**MONTGOMERY COUNTY HISTORIC PRESERVATION COMMISSION**  
**STAFF REPORT**

<b>Address:</b>	4811 Cumberland Ave., Chevy Chase	<b>Meeting Date:</b>	7/15/2020
<b>Resource:</b>	Primary (Pre-1915) Resource (Somerset Historic District)	<b>Report Date:</b>	7/8/2020
<b>Applicant:</b>	James Belikove & Vanessa Piala (Jason Arce, Agent)	<b>Public Notice:</b>	7/1/2020
<b>Review:</b>	Preliminary Consultation	<b>Tax Credit:</b>	N/A
<b>Case Number:</b>	N/A	<b>Staff:</b>	Michael Kyne
<b>PROPOSAL:</b>	Construction of new rear addition, hardscape alteration

Staff recommends that the applicants make any revisions based upon the HPC's comments and return with a HAWP application.

**Fig. 2: 1927 Sanborn Fire Insurance Map.**

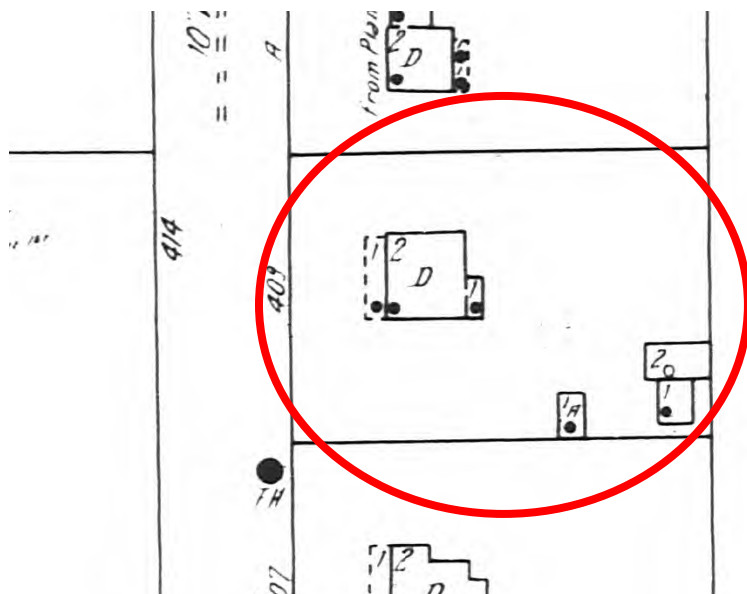
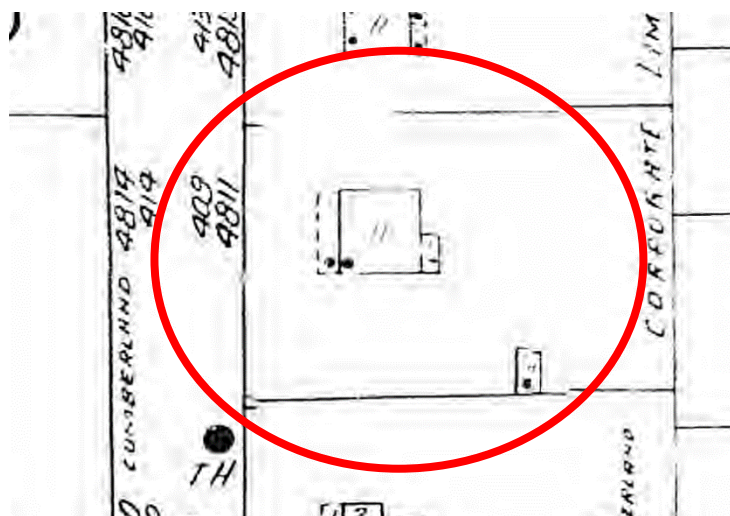
The applicants propose to remove an existing porch from the rear/right (northeast) corner of the house. Additionally, the applicants propose to remove an existing walkway connecting the porch to be removed to another porch in the rear/left (northwest) corner of the house. A new one-story building addition is proposed in place of the porch and walkway to be removed. A bay window on the right (east) side of the house will also be removed, with French doors installed in its place. Although the application states that there have been three or four previous additions to the historic house, it is unclear whether the features to be removed are original to the house or previous additions.

Staff seeks additional information from the applicants regarding the date of construction of the features to be removed (i.e., porch, walkway, bay window). Staff also seeks additional regarding the proposed replacement retaining wall information (i.e., height, materials, fencing or other features). Staff asks for the Commission's guidance regarding the proposed demolition/alterations, based upon any additional information provided by the applicants.
